GE-MNGP-AEP-1913 R1

GEH Responses to Reactor Systems RAIs – Non-proprietary

Reactor Systems RAI-01

Figure RAI-02 2.7 Dimensionless Bundle Power at 200 MWd/ST

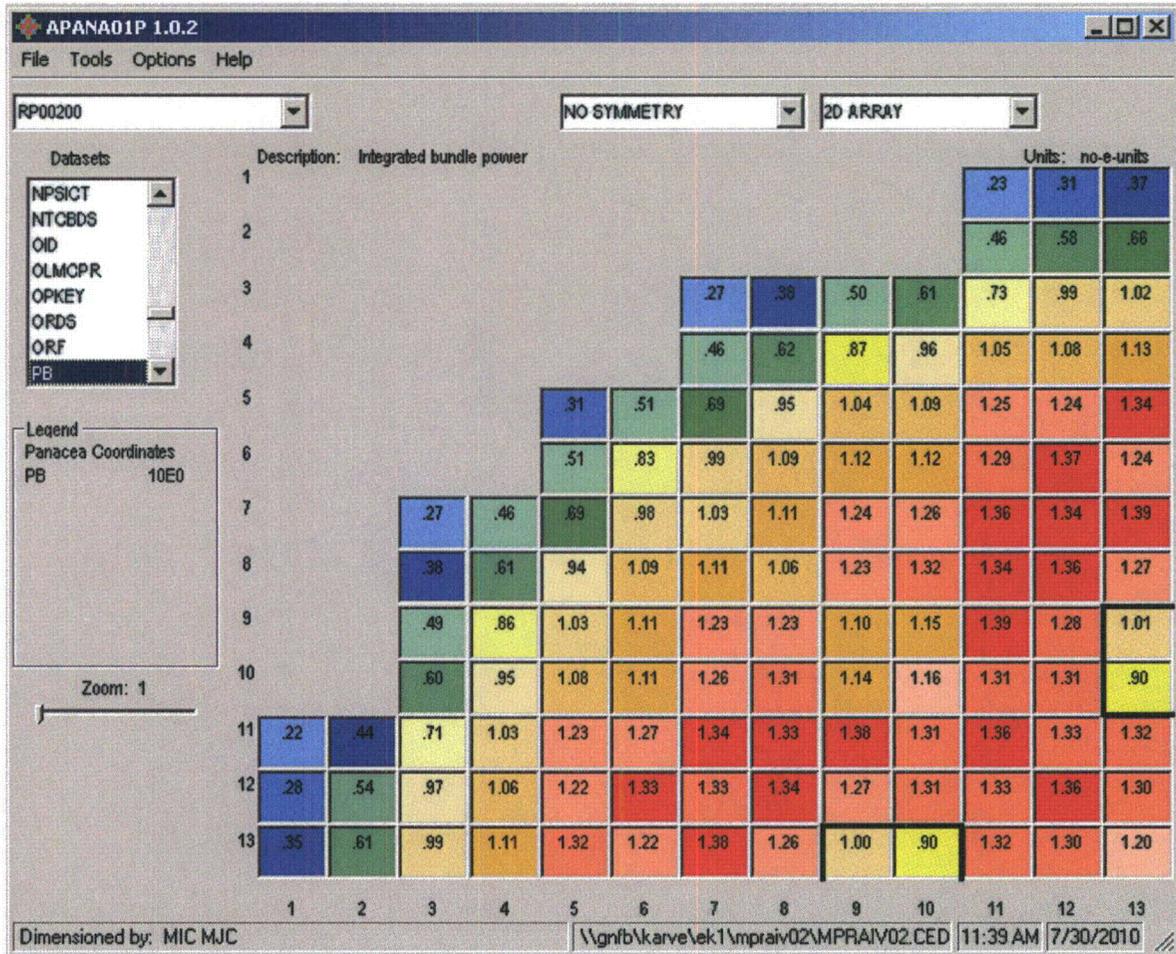
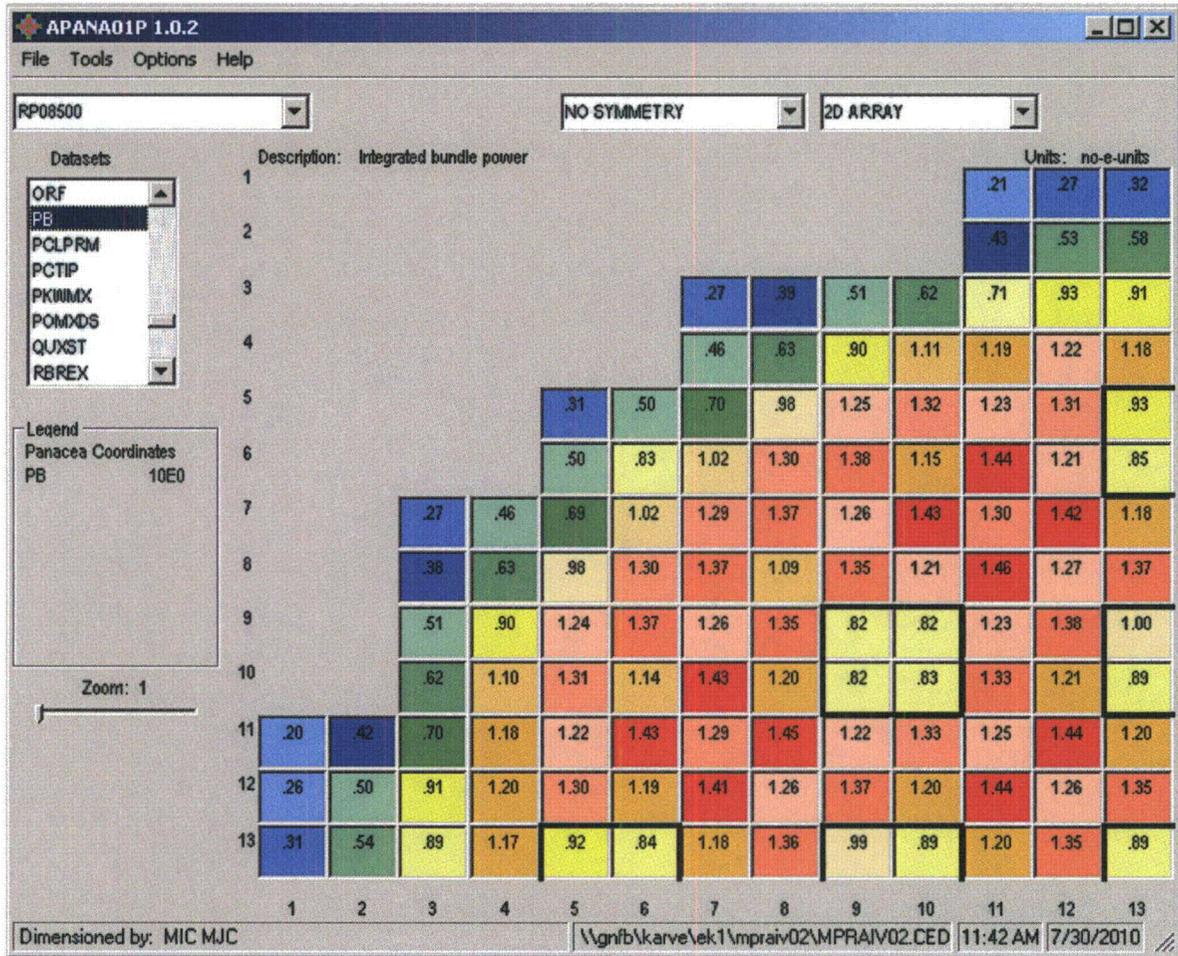
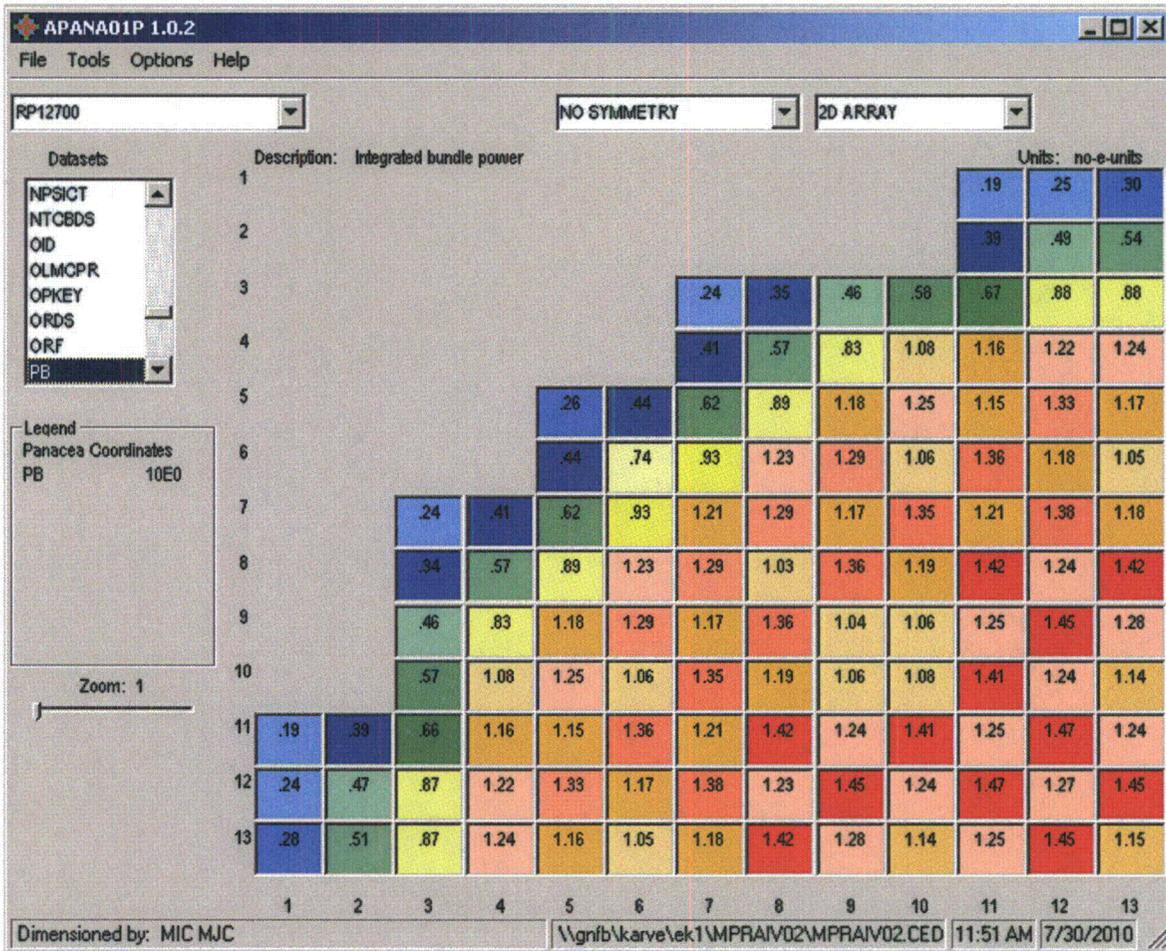
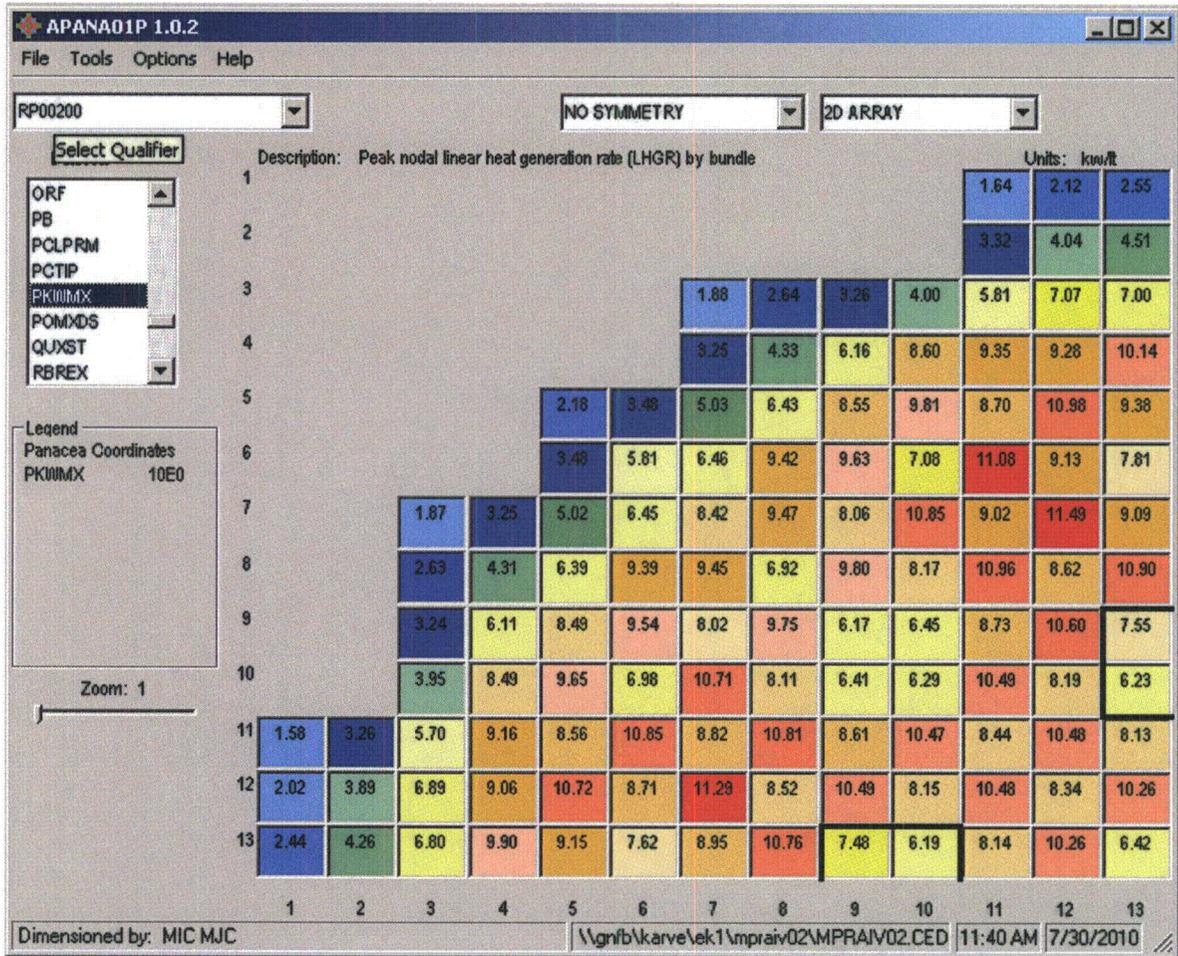
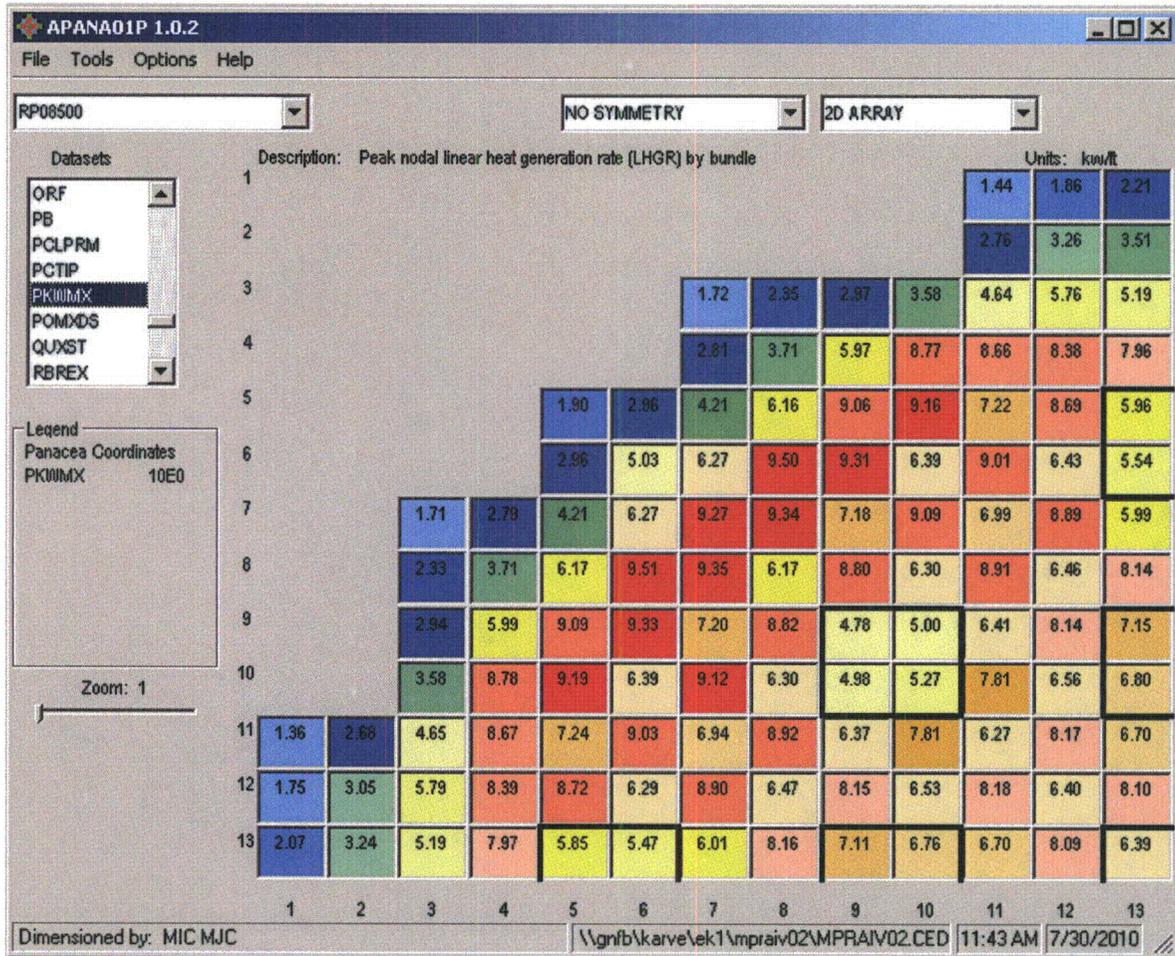
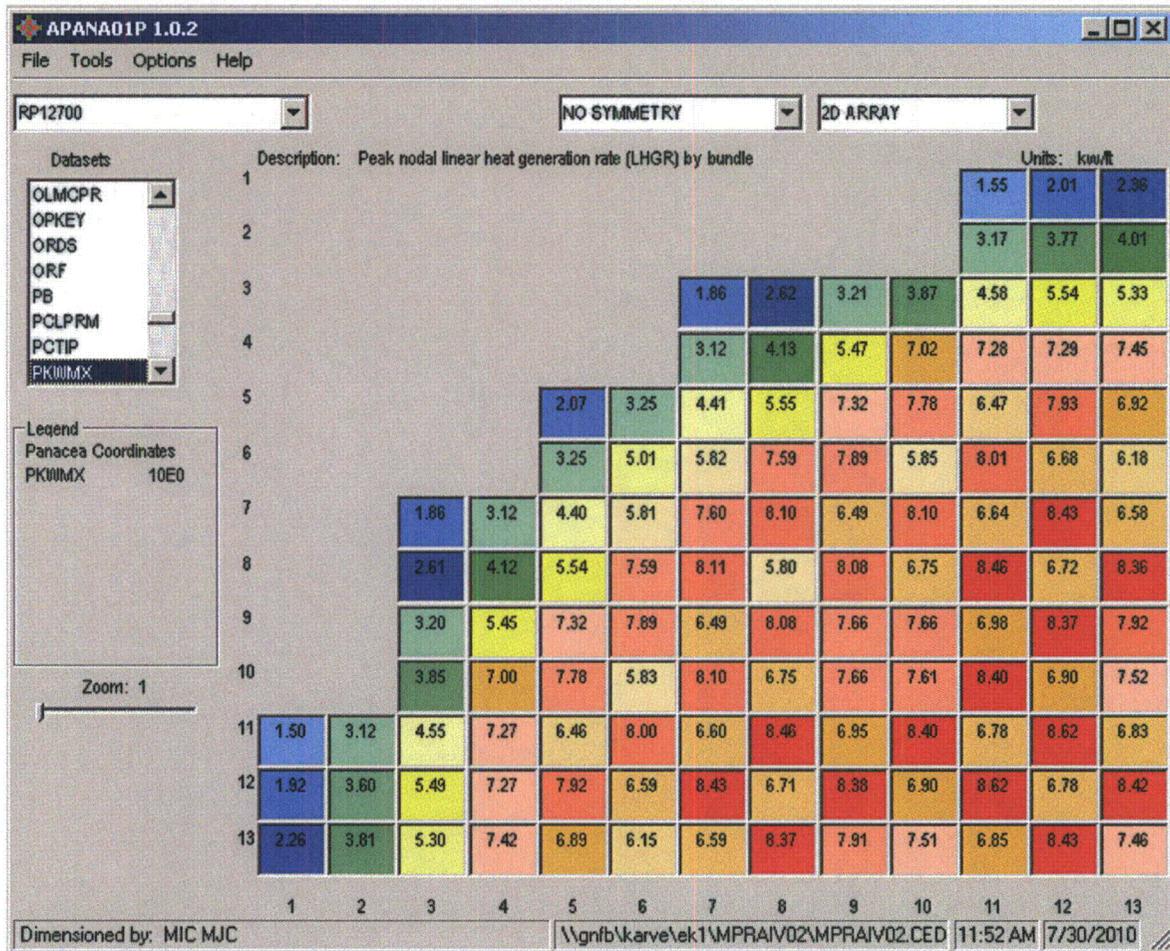
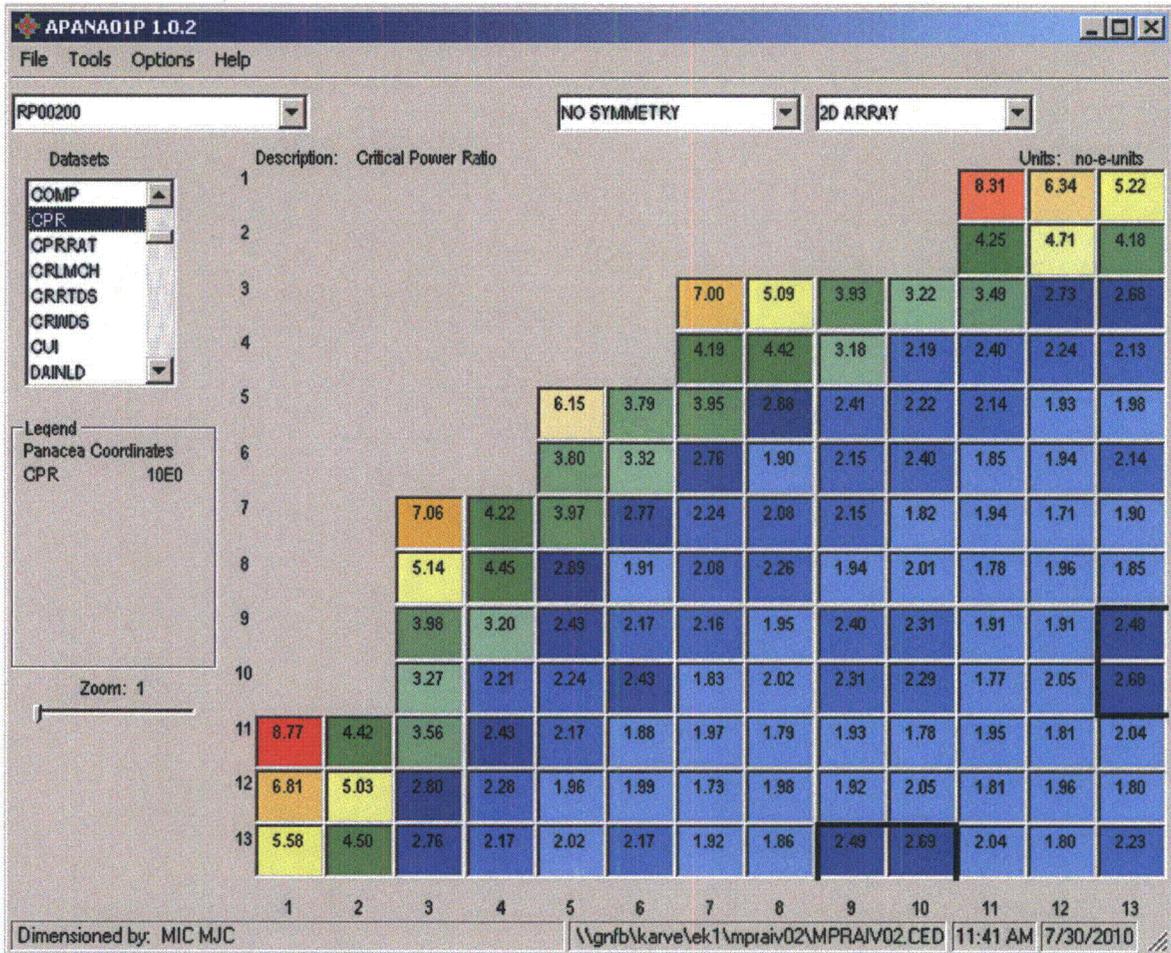
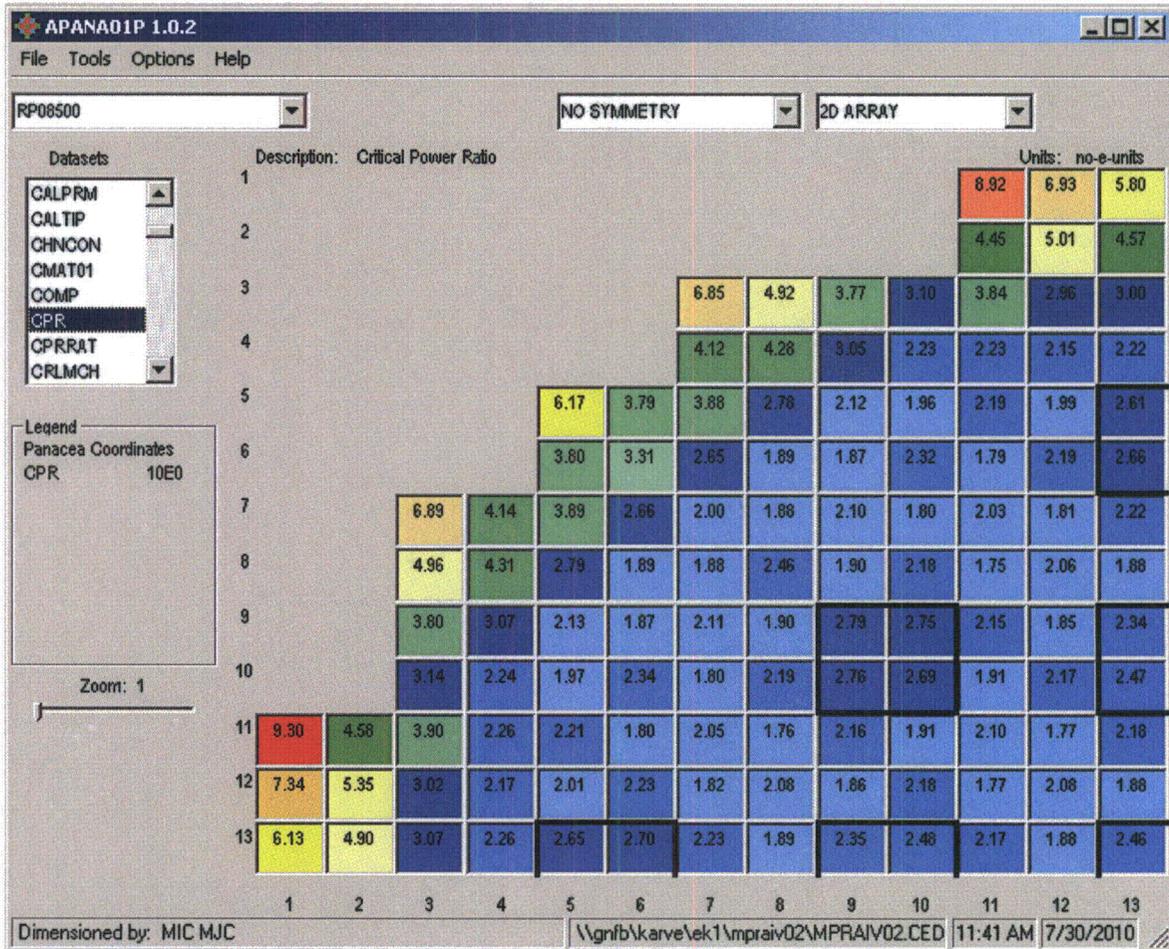
Section 2.1.2 of NEDC-33435P/Rev1 states that “Because there is no increase in the average bundle power or in the maximum allowable peak bundle power there is no change required to the fuel thermal monitoring threshold.” Figures 2-7 through 2-17 provide 2D bundle distributions for relevant parameters for the representative MELLLA+ core. Provide similar figures for the last non-MELLLA+ Monticello core.

As clarified and agreed on the phone call with the NRC on July 19, 2010, the following figures for the cycle 25 Extended Power Uprate (EPU) reload licensing core are “representative” of the last non-MELLLA+ Monticello core. The ¼ core maps are shown as Figures RAI-02 2-7 through 2-17 consistent with the figures (and figure numbers) in NEDC-33435P, Revision 1 (Reference RAI-02-1). The cycle 25 licensing calculations were performed at an EPU power of 2004 MWt and designed for nominal cycle energy of [[.....]]. The 200 MWd/ST cycle exposure represents the beginning-of-cycle (BOC) point, the 8,500 MWd/ST cycle exposure represents the middle-of-cycle (MOC) point, and the 12,700 MWd/ST cycle exposure represents the end-of-cycle (EOC) point. The peak Maximum Fraction of Limiting Critical Power Ratio (MFLCPR) point is at a cycle exposure of 11,000 MWd/ST and the peak Maximum Fraction of Limiting Power Density (MFLPD) point is at a cycle exposure of 12,500 MWd/ST. All points are adjusted to be at the 100% EPU power level. The flows at the BOC, MOC, peak MFLCPR, and MFLPD points are adjusted to the 99% rated flow and the EOC point is adjusted to the 105% rated flow. The EOC point is an all rods out condition.
